Request for Deferral of PED Ramp Approval to Sign-Off

The BPP Application No. 540265853 for 68 Seneca Avenue was filed by our office and has received several objections. In response, we have obtained all required DOT waivers and addressed all outstanding comments, with the exception of Item No. 5, referencing Section of Code - DOT/R&R (IX)(E)(f)(2), which states:

Thank you for submitting the following Builder's Pavement Plan (BPP) dated 8/7/2024 for New York City Department of Transportation's (NYC DOT) review;

BBL: 5-00654-0039-0040 DOB Job#: 540265853 Address: 68 Seneca Avenue

BPP-001.00

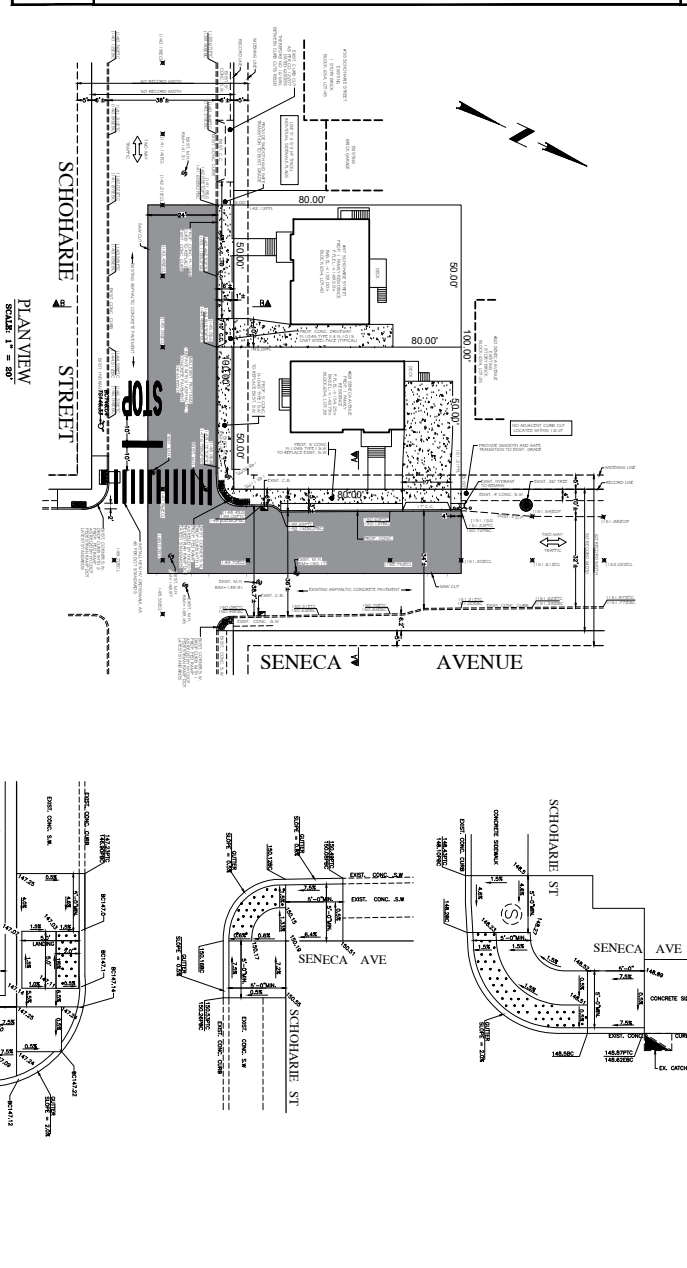
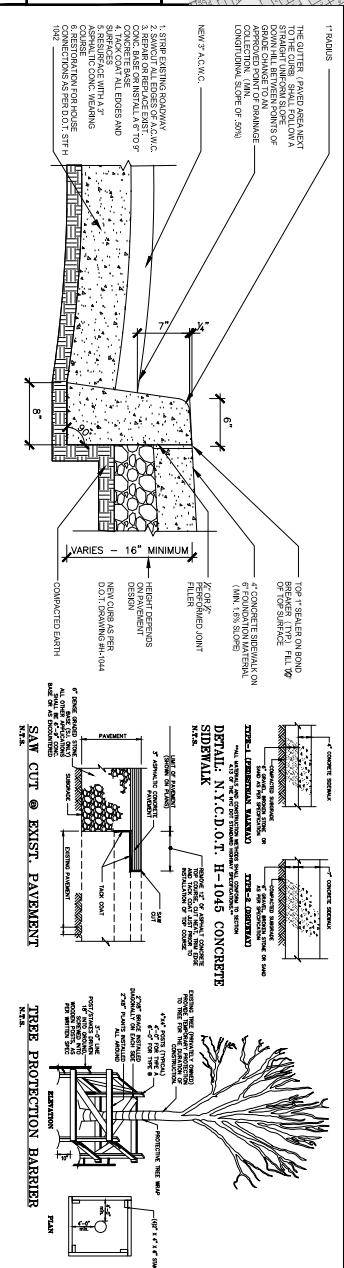
1. **Scope of resurfacing** – BPP must resurface minimum half the roadway width plus 5' on both sides of the property, including the intersection. Scope of resurfacing must extend to where the two resurfacing extent lines meet at the intersection.

2. **Roadway markings** – Stop bar should be 10' away from the crosswalk markings per the [NYC DOT markings typical](#).
3. **Back-pitched sidewalk** – Sidewalk appears to be back-pitched toward the property on Seneca Ave at the corner. Water should drain toward the curb.

4. **Sidewalk cross slope** – Sidewalk cross slope on Seneca Ave at the corner appears to exceed 2.0%. Sidewalk, including but not limited to the corner quadrant, must provide a minimum 5'-0" wide pedestrian access route (PAR), designed with 1.5% maximum cross slopes, constructed slopes not to exceed 2.0% (typ. for all sidewalks).

5. **Discrepancy** – There is a discrepancy between the PPL shown at the end of the property on Seneca Ave in the drawing (PPL 151.31) and that shown in the street profile (PPL 151.4). Resolve discrepancy.

6. **Slope arrows** – Verify slope directions in all pedestrian ramp details as many appear to be pointing in the opposite direction.

7. **Grade breaks at detectable warning surfaces (DWS)** – All pedestrian ramp details show a grade break at the DWS. Remove grade breaks and instead have a constant slope from the top of the landings to the bottom.

8. **BPP corner (NWC):**
 - a. **Grass at the back of sidewalk** – Confirm whether grass will be planted at the current back of sidewalk (between record line and street widening line). If it will be replaced with concrete, change the ramp type at the BPP corner to a Case C5 Blended Transition ramp.

- b. **Landing slope** – Verify the slope calculation at the top of the landing (between EL 148.54 and 148.27). Landing space slopes should be designed to be maximum 1.5% (constructed not to exceed 2.0%).

9. **Receiving corner across Seneca Ave (NEC): Bottom landing space** – There must be a minimum 4'x4' bottom landing space that is entirely within the crosswalk (marked or unmarked) in both directions.

10. **Receiving corner across Schoharie St (SWC):**
 - a. **Width of landings** – Landings should be the whole width of the sidewalk, not just 5'x5' to avoid a grade break that could cause a trip hazard. Specify elevations at the back of sidewalk.

- b. **Orientation** – Landing appears to be slanted. Orient landing to be as parallel to the crosswalk as drainage and grading allow.
 - c. **Gutter slope** – Gutter slope, including around corners and at the bottom of the ramps, must be minimum 0.5% to avoid ponding.

- d. **Ramp lengths** – Parallel ramps must be minimum 2'-6" long.
 - e. **Curb reveal** – Ramps must have minimum 2" curb reveals.

1. Scope of resurfacing – BPP must resurface minimum half the roadway width plus 5' on both sides of the property, including the intersection. Scope of resurfacing must extend to where the two resurfacing extent lines meet at the intersection. – **Resurface has been extended**
2. Roadway markings – Stop bar should be 10' away from the crosswalk markings per the NYC DOT markings typical. **Stop Bar has been modified to 10'**

3. Back-pitched sidewalk – Sidewalk appears to be back-pitched toward the property on Seneca Ave at the corner. Water should drain toward the curb. **Slope has been revised to pitch towards the curb**

4. Sidewalk cross slope – Sidewalk cross slope on Seneca Ave at the corner appears to exceed 2.0%. Sidewalk, including but not limited to the corner quadrant, must provide a minimum 5'-0" wide pedestrian access route (PAR), designed with 1.5% maximum cross slopes, constructed slopes not to exceed 2.0% (typ. for all sidewalks). **The sidewalk slope has been revised**

5. Discrepancy – There is a discrepancy between the PPL shown at the end of the property on Seneca Ave in the drawing (PPL 151.31) and that shown in the street profile (PPL 151.4). Resolve discrepancy. **PPL discrepancy has been revised**

6. Slope arrows – Verify slope directions in all pedestrian ramp details as many appear to be pointing in the opposite direction. **The slope arrows have been revised**

7. Grade breaks at detectable warning surfaces (DWS) – All pedestrian ramp details show a grade break at the DWS. Remove grade breaks and instead have a constant slope from the top of the landings to the bottom. **Can you please clarify what section of the regulations indicates this requirement**

8. BPP corner (NWC):
 - a. Grass at the back of sidewalk – Confirm whether grass will be planted at the current back of sidewalk (between record line and street widening line). If it will be replaced with concrete, change the ramp type at the BPP corner to a Case C5 Blended Transition ramp. **Grass will be planted**

- b. Landing slope – Verify the slope calculation at the top of the landing (between EL 148.54 and 148.27). Landing space slopes should be designed to be maximum 1.5% (constructed not to exceed 2.0%). **Slope has been revised**

9. Receiving corner across Seneca Ave (NEC): Bottom landing space – There must be a minimum 4'x4' bottom landing space that is entirely within the crosswalk (marked or unmarked) in both directions. **4x4 space has been added to show entire landing is within crosswalk**

- a. Width of landings – Landings should be the whole width of the sidewalk, not just 5'x5' to avoid a grade break that could cause a trip hazard. Specify elevations at the back of sidewalk. **Same slope has been extended passed the 5'x5 to avoid any trip hazard. Grades have been added**
- b. Orientation – Landing appears to be slanted. Orient landing to be as parallel to the crosswalk as drainage and grading allow. **Landing has been revised**
- c. Gutter slope – Gutter slope, including around corners and at the bottom of the ramps, must be minimum 0.5% to avoid ponding. **Gutter slope is more than 0.5%**
- d. Ramp lengths – Parallel ramps must be minimum 2'-6" long. **Can you kindly mark up the plan so that we can revise the plan**

e. Curb reveal – Ramps must have minimum 2” curb reveals. All curb reveals are 2” min
